NUREG/CR-XXXX  
PNNL-XXXXX

**Ultrasonic Phased Array  
Assessment of the Interference  
Fit and Leak Path of the  
North Anna Unit 2 Control Rod  
Drive Mechanism Nozzle 63 with  
Destructive Validation**

G. Oberson, NRC Project Manager

Figure 1.1 CRDM J-groove Weld Schematic

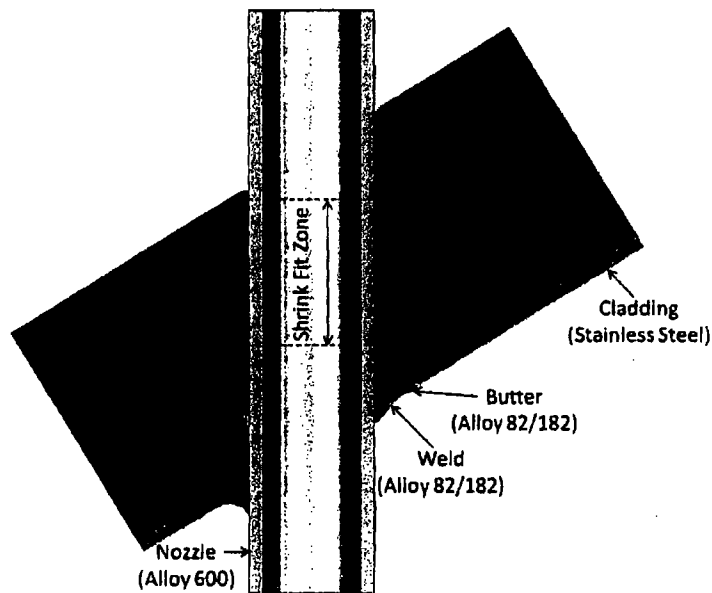
Comment [PG03]: Why doesn't the shrink fit go down to the top of the J-groove weld?

Figure 3.2 5.0-MHz Phased Array Probe

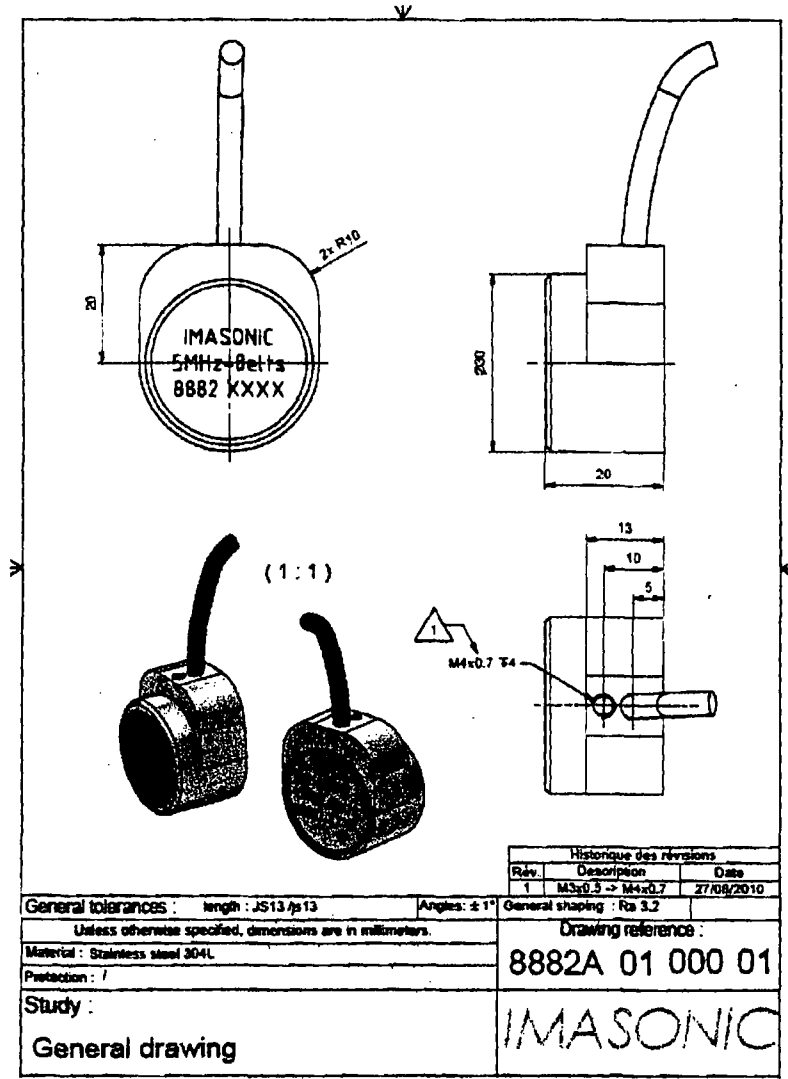
Comment [PG04]: Do you have (or need) permission to use this figure?

Figure 3.4 Laser Formation and Round Field Simulation for a Depth Focus of 15 mm

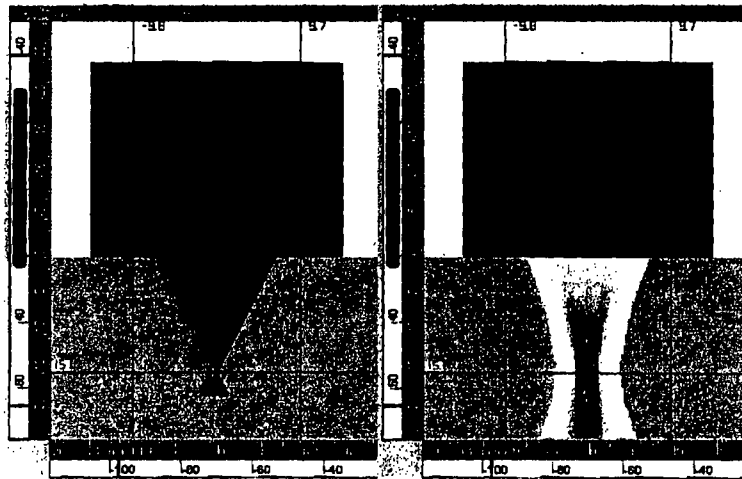
Comment [PG05]: Where is probe in this figure?

**Figure 3.6 Scanning Setup Orientation Schematic**

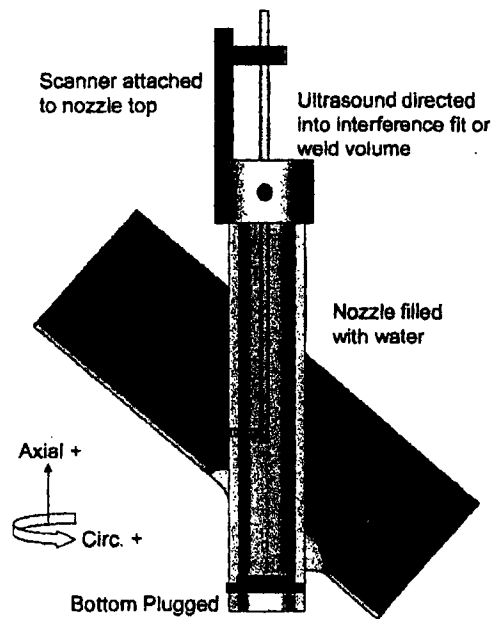
Comment [PG07]: Same as figure 5.3

**Figure 4.18** C-scan Plan View of the Notches in the Carbon Steel from the First Ultrasonic Echo

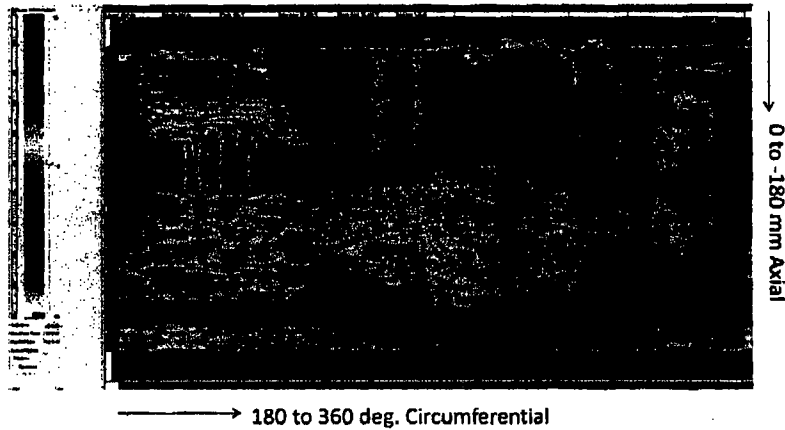
Comment: [PG 18] State what is circled.

**Figure 4.19 C-scan Plan View of the Depth Notches in Carbon Steel, on the Upper Right.**  
 This image was acquired from the first ultrasonic echo.

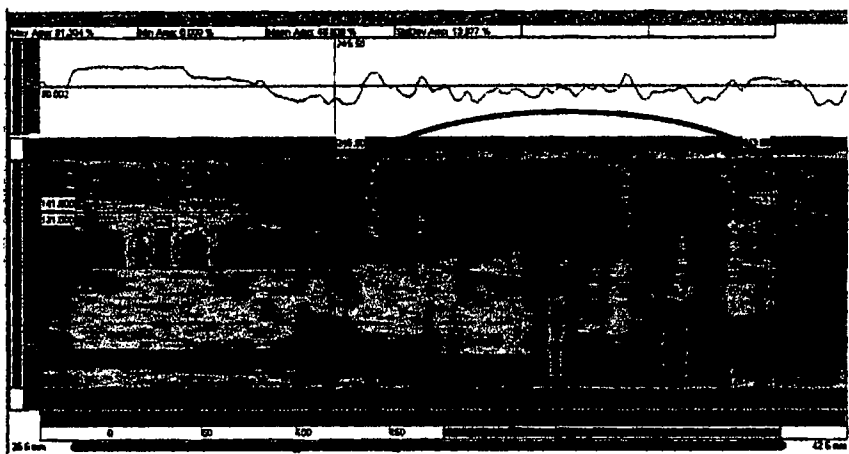
Comment [PG016]: Say what is circled.

Figure 4.22 C-scan Plan View of the Boric Acid Deposits in the Lower Interference Fit Region. The horizontal axis represents the circumferential range of 60–240 degrees. ~~This image is from the first ultrasonic echo.~~

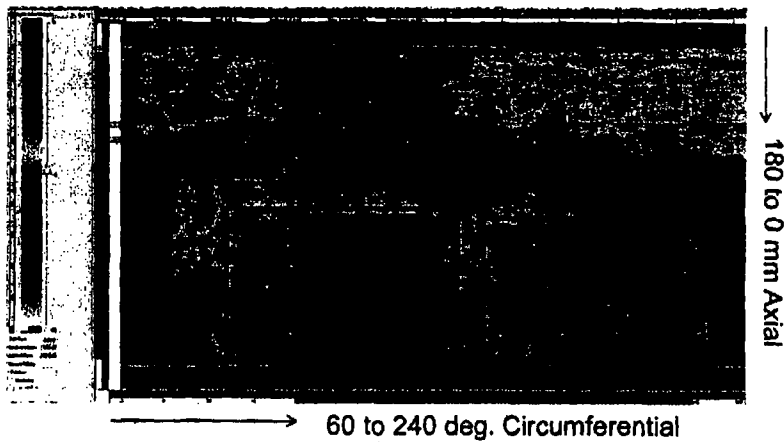
Comment [PG019]: Say what is boxed.

Figure 5.3 Schematic of Nozzle Assembly and Ultrasonic Evaluation of the Interference Fit

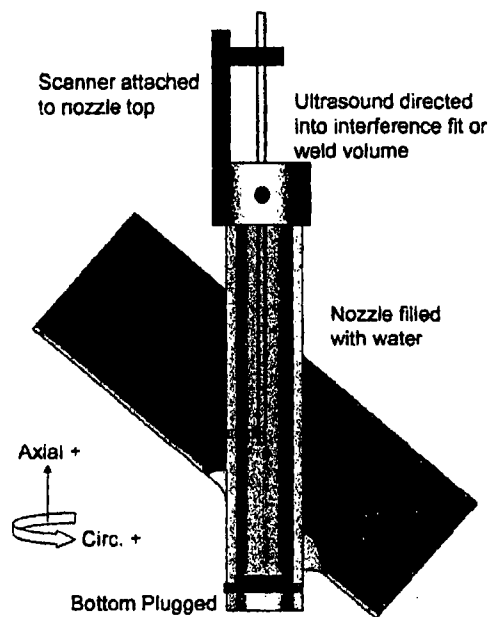
Comment [PG024]: You have already used this image (Fig. 3.8). Do not repeat it. Reference previous figure if necessary.

Figure 7.2 RPV Head Surface Stretched Image of the Head Annulus Direction

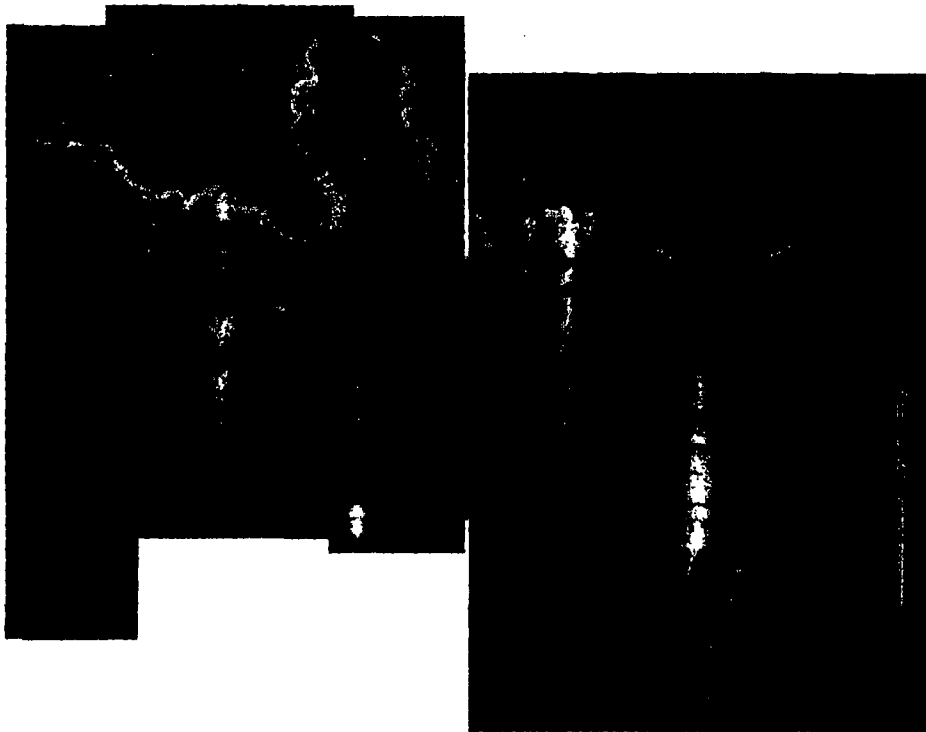
Comment: 160551: See comment on Figure 7.3. This figure should be on the same page as the UT data so that they can be easily compared.

Figure 7.3 Ultrasonic Data Overlaid on RPV Head Photograph with Opacity Varying from 10 to 80%, Top to Bottom

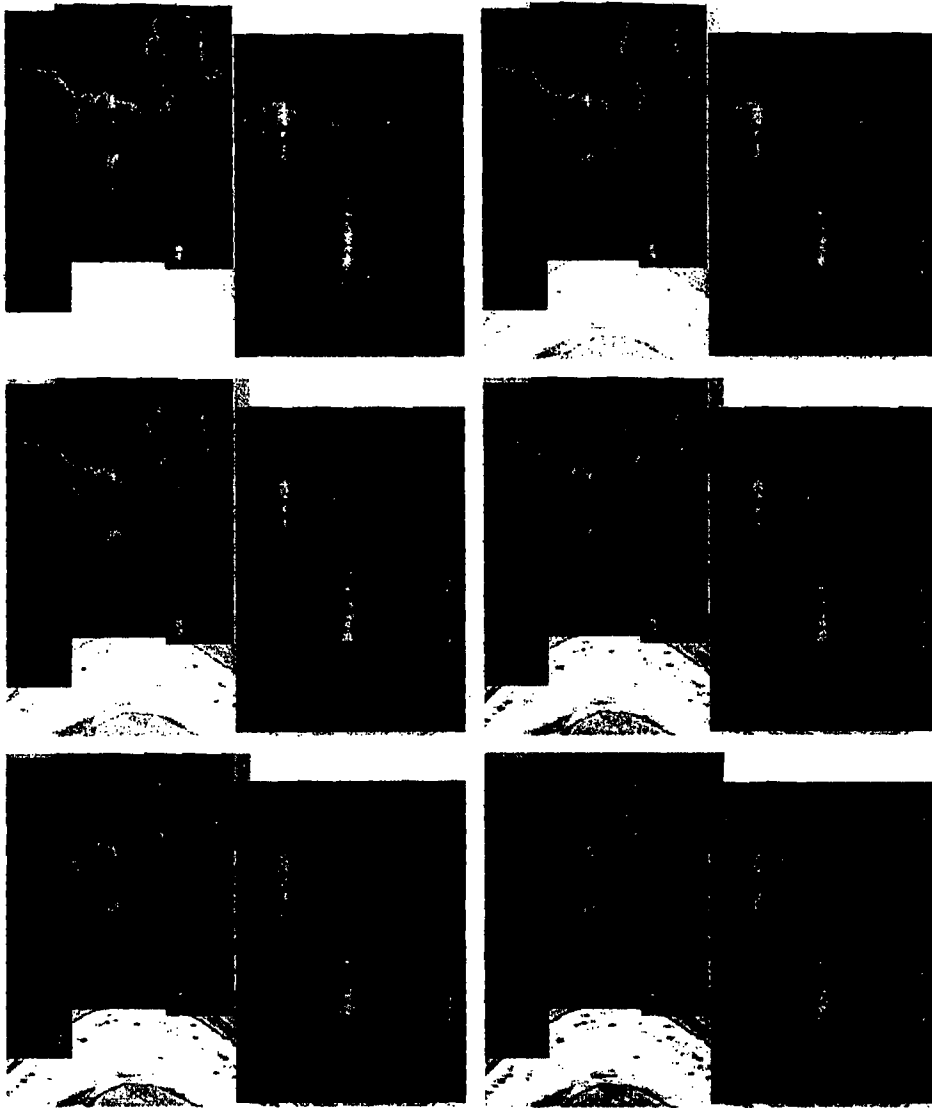
Comment: (P6056) you don't need all the overlaid angles. We do need on the same: Figure 7.3 and the OT data in the same to scale next to each other, be one on top of the other.
